Application No. 10/713,437

AMENDMENTS TO THE DRAWINGS

REMARKS

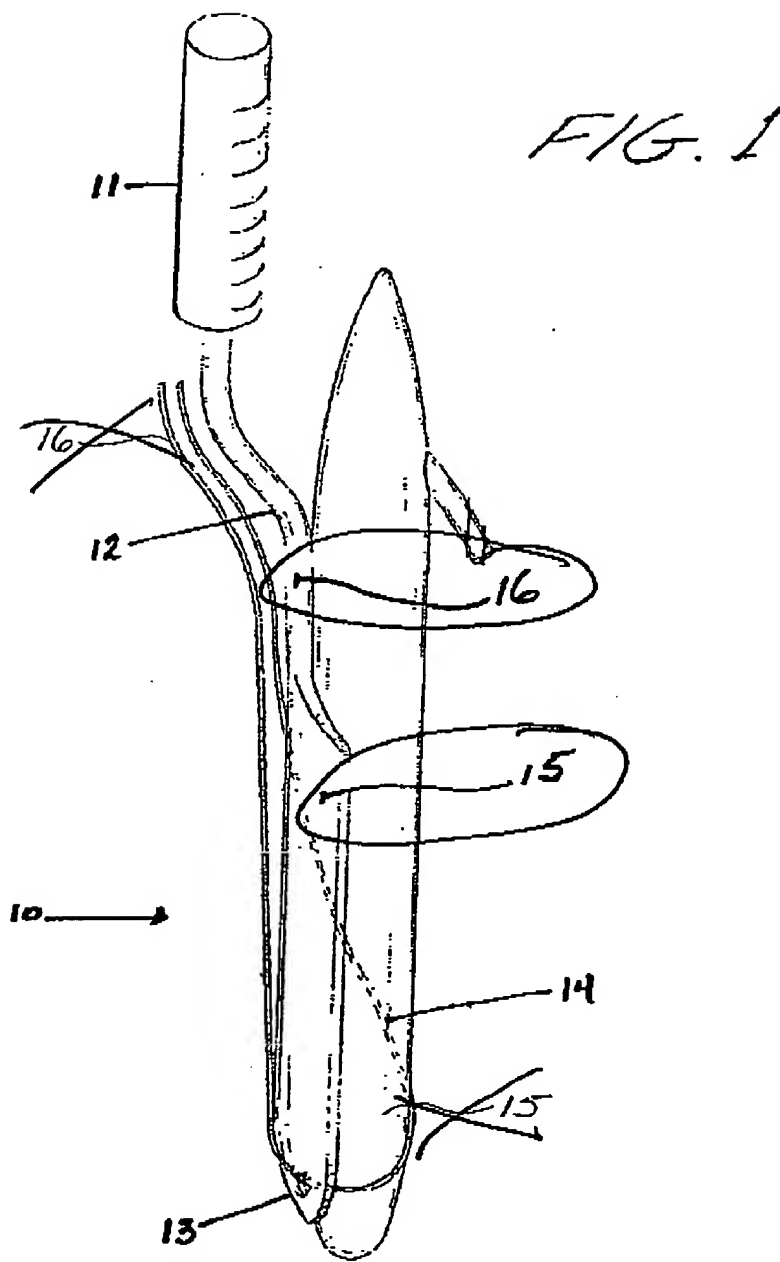
Fig. 1 has been amended to include additional item numbers that correspond with the description amended in the specification. Specifically, item numbers 15 and 16 have been added to Fig. 1, wherein item number 15 is the outwardly angled shaft section and item number 16 is the linear handle section.

Applicant has amended Fig. 1 to include additional item numbers that correspond with the description amended in the specification. Specifically, item numbers 15 and 16 have been added, wherein item number 15 is the outwardly angled shaft section and item number 16 is the linear handle section. The location of item numbers 15 and 16 have changed from the last amendment. The outwardly angled shaft section 15 is outwardly angled from the center line of the linear handle section. The portion of the outwardly angled shaft section 15 that is visible on Fig. 1 is replicated on the other side of the tool, and together, the outwardly angled shaft section and its replicate form a convexity, or a roundness in the tool so that it may fit over the rounded prosthesis. Applicant submits that the drawings should now be clear and requests that the objection to the drawings be withdrawn.

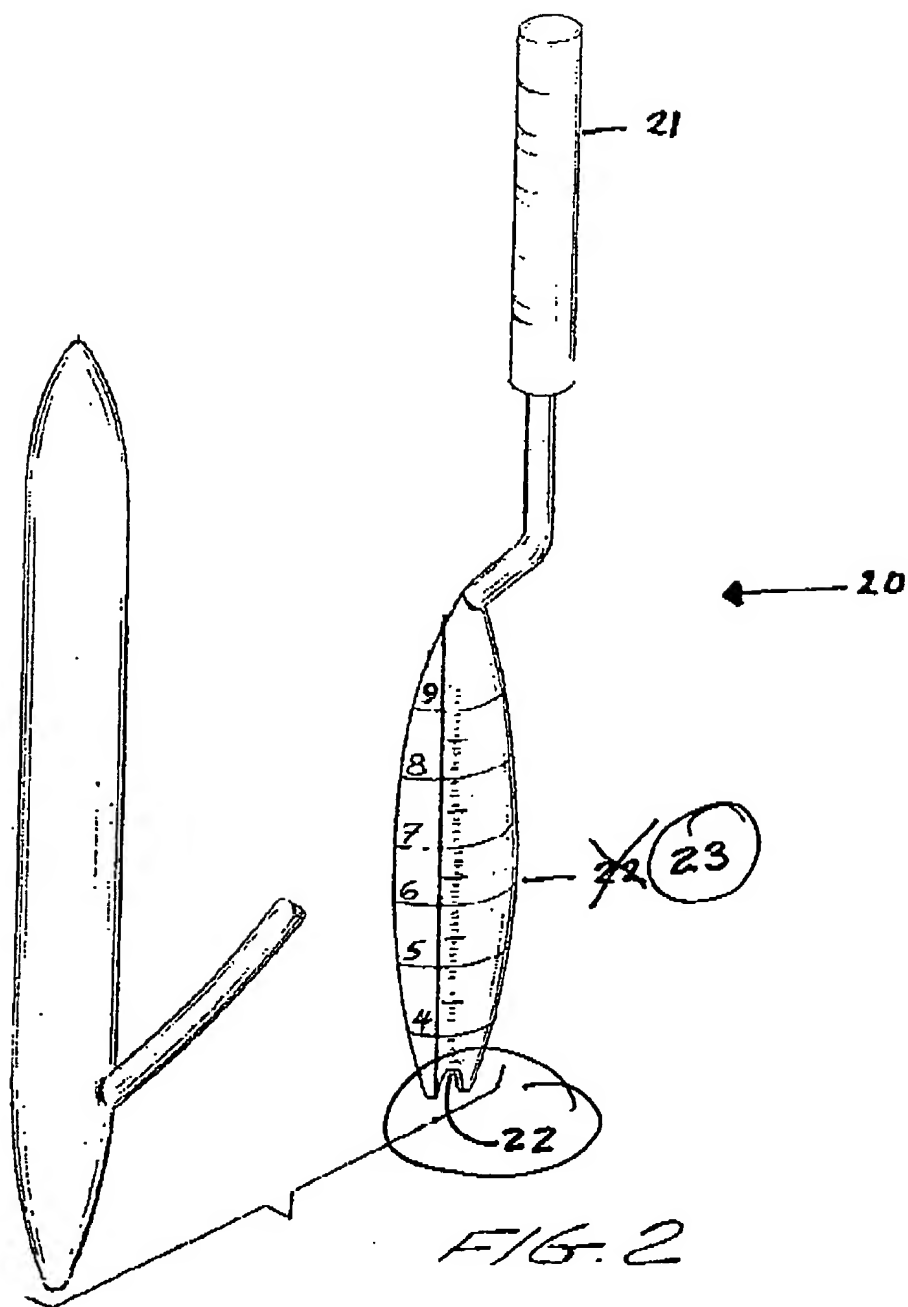
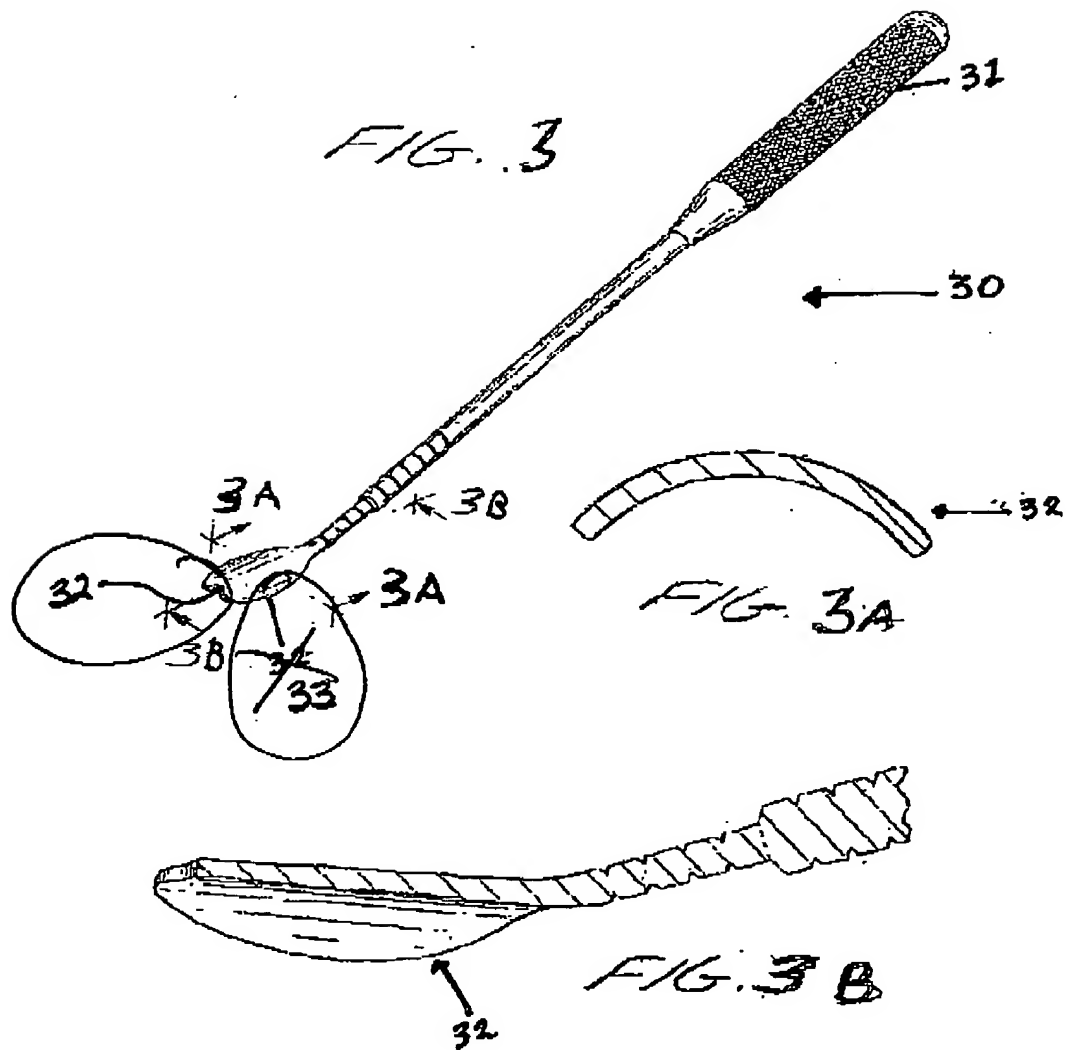
Figs. 2 and 3 have been amended to include additional item numbers that correspond with the description amended in the specification. Specifically, item numbers 23 and 33 have been added to identify the shaft. Item numbers 22 and 32 have been moved to point more particularly to the receptacle (notch) of the tool.

Applicant has amended Figs. 2 and 3 to add item numbers 23 and 33 which identify the shaft, in cooperation with the amendment to the specification presented above. Item numbers 22 and 32 have been moved on the drawing to show that they refer to the notch, or receptacle, at the end of the shaft of the tool.
